**From:** [Jeff Adams](#)  
**To:** [Roe, Dilan, Env. Health](#)  
**Subject:** Jordan Ranch - maps and discussion  
**Date:** Friday, February 15, 2013 9:34:06 AM  
**Attachments:** [7828000001-ParcelH-1-GroundwaterAssessment-021113-REVIEW3.pdf](#)  
[Jordan vicinity overview.pdf](#)

GROUNDWATER ASSESSMENT  
 JORDAN RANCH - PARCEL H  
 DUBLIN, CALIFORNIA

**From:** Roe, Dilan, Env. Health  
**To:** "[Lockwood, George@Waterboards](mailto:Lockwood.George@Waterboards)"  
**Cc:** [Drogos, Donna, Env. Health](#); "[Ravi Nandwana](#)"; [Jeff Adams](#)  
**Subject:** RE: JORDAN RANCH (T06019797353), 4233 FALLON  
**Date:** Friday, February 15, 2013 4:12:00 PM

**From:** Lockwood, George@Waterboards [mailto:George.Lockwood@waterboards.ca.gov]  
**Sent:** Friday, February 15, 2013 1:07 PM  
**To:** Drogos, Donna, Env. Health; Roe, Dilan, Env. Health  
**Subject:** JORDAN RANCH (T06019797353), 4233 FALLON

FIGURE NO. 1

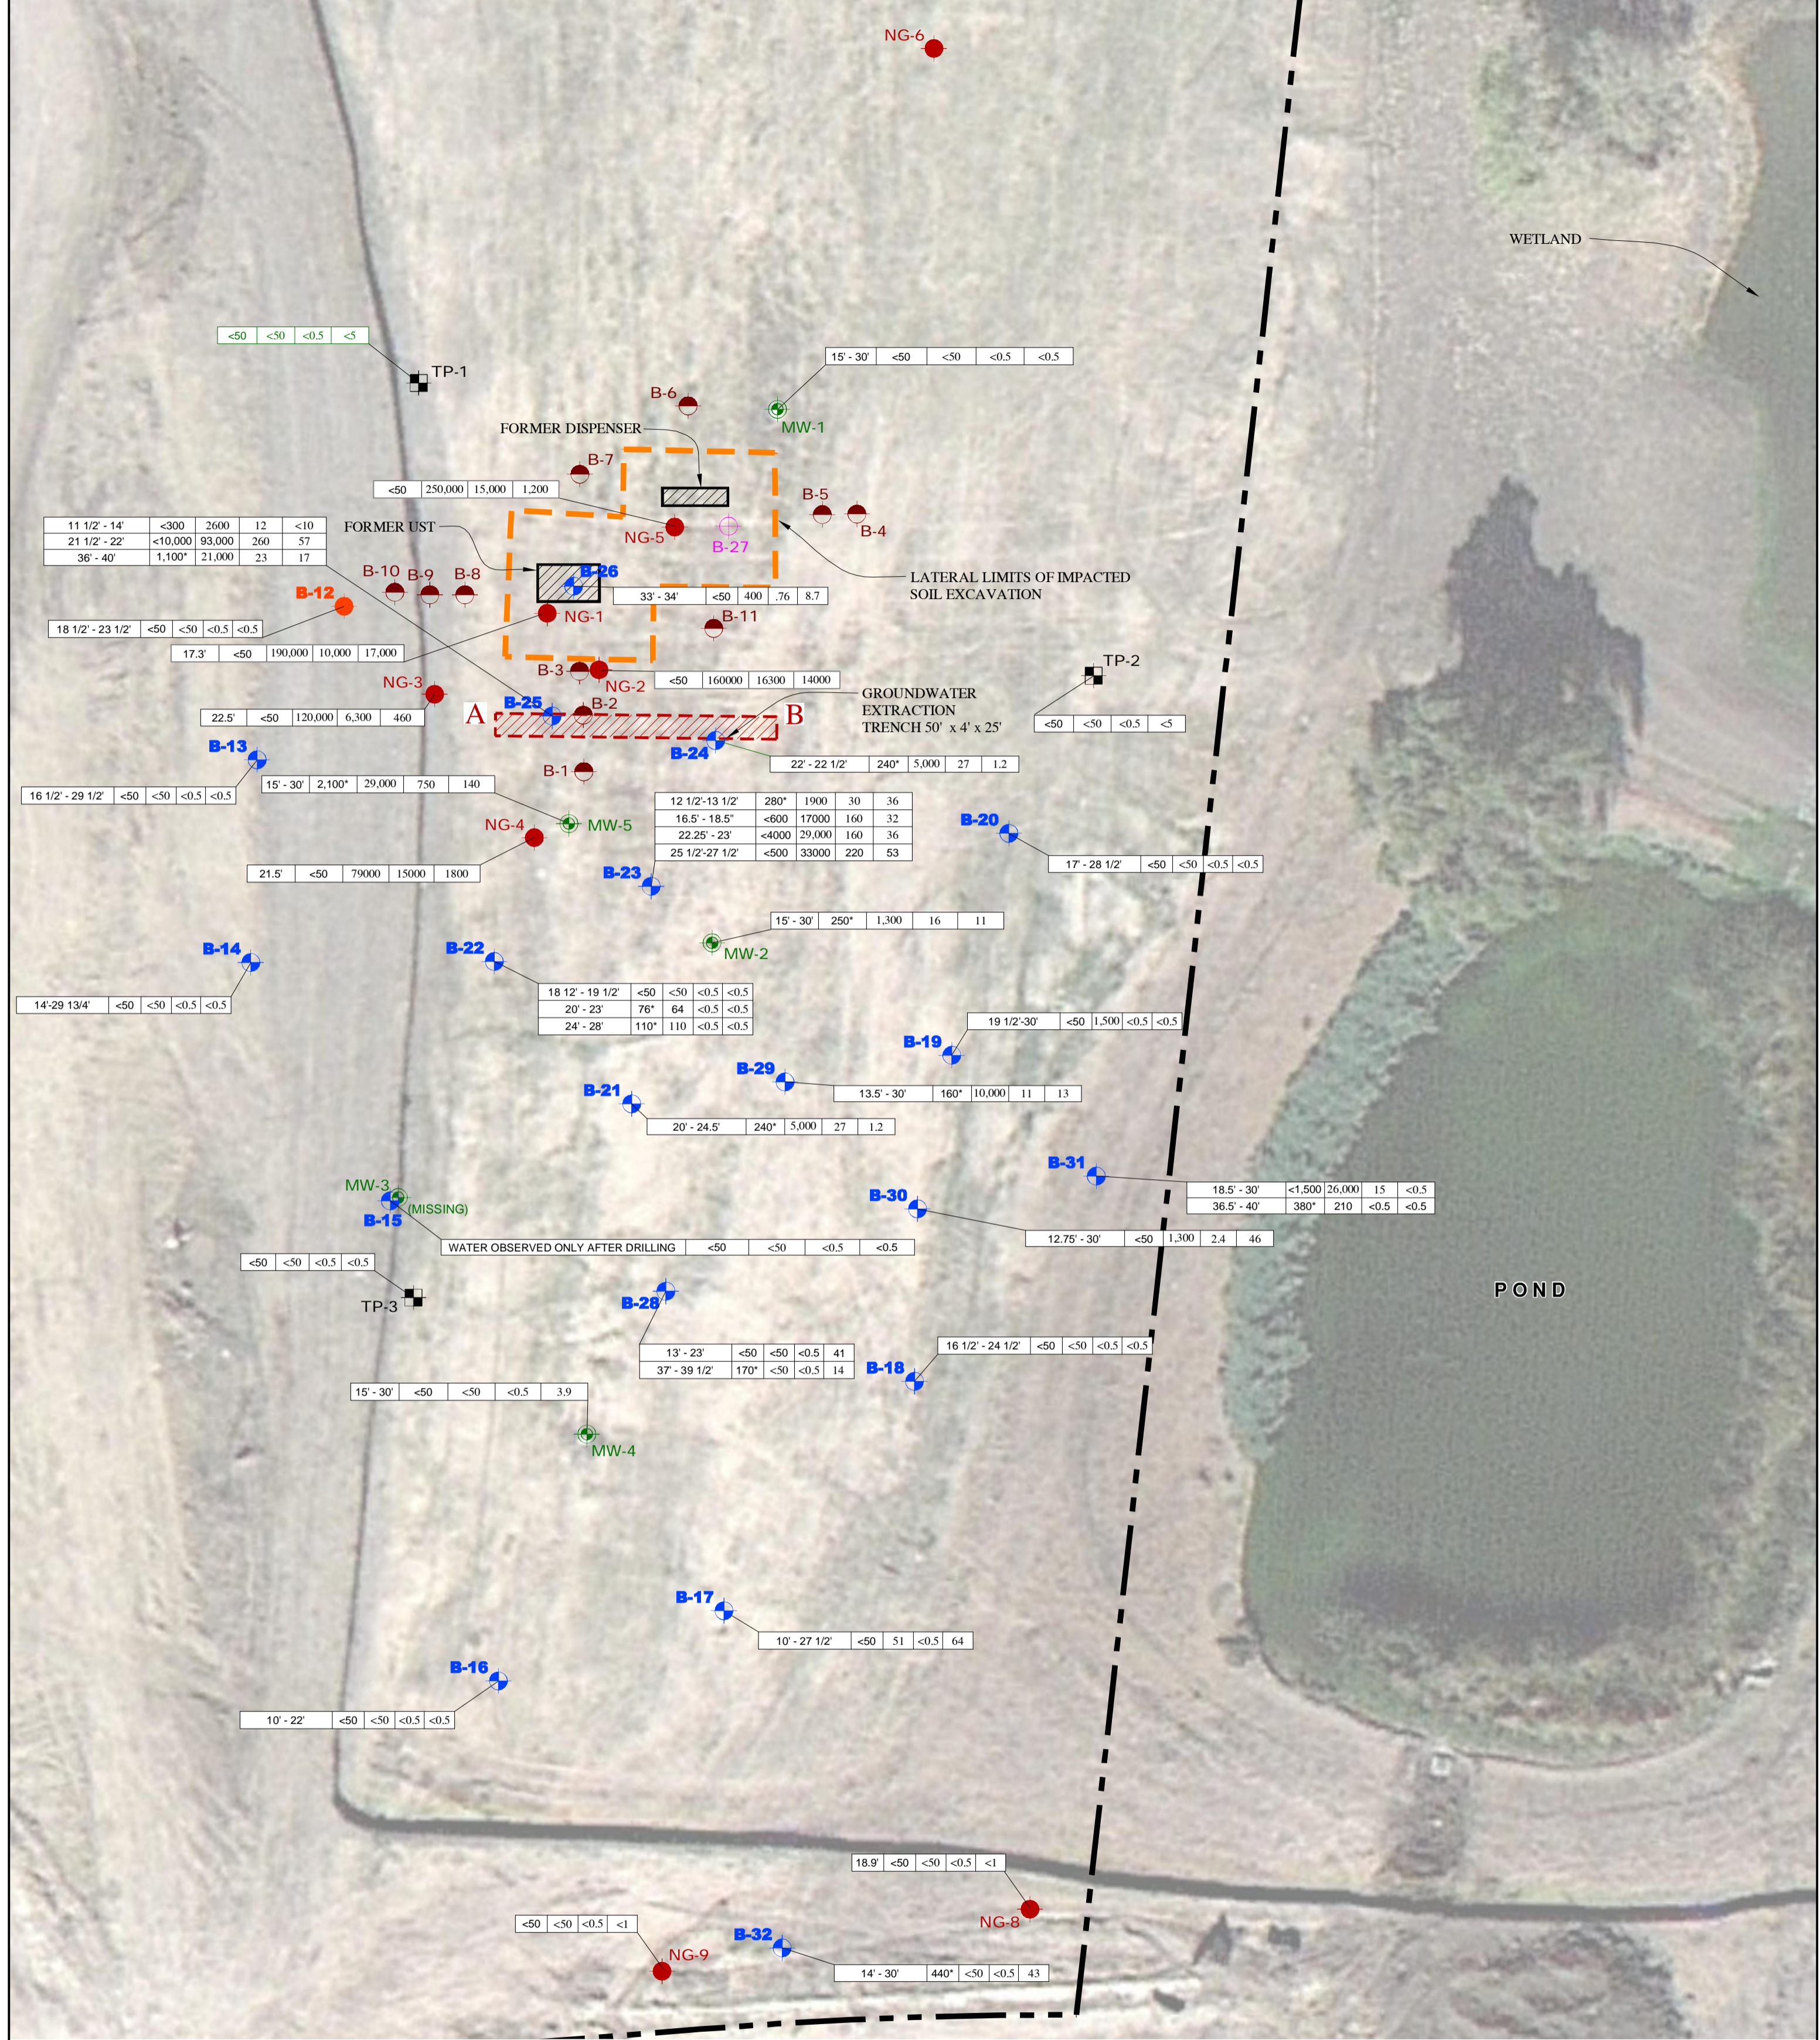
Thank-you for bringing this to our attention. I have adjusted the site location on the GeoTracker map to accurately locate its position. The monitoring wells are located incorrectly (i.e., they should be located west of the pond rather than to the east as currently site). I have rejected the GEO\_XY and GEO\_Z data on GeoTracker and requested the RP's consultants to verify the survey data, and re-upload to GeoTracker in order to properly locate the wells.

Please check the location of this site in relation with the four ESI points associated with the site. It appears that either the site or the wells are not located correctly. If it is the site, one can relocate it in GeoT. If it is the ESI, the ESI will have to be denied and the re-uploaded.
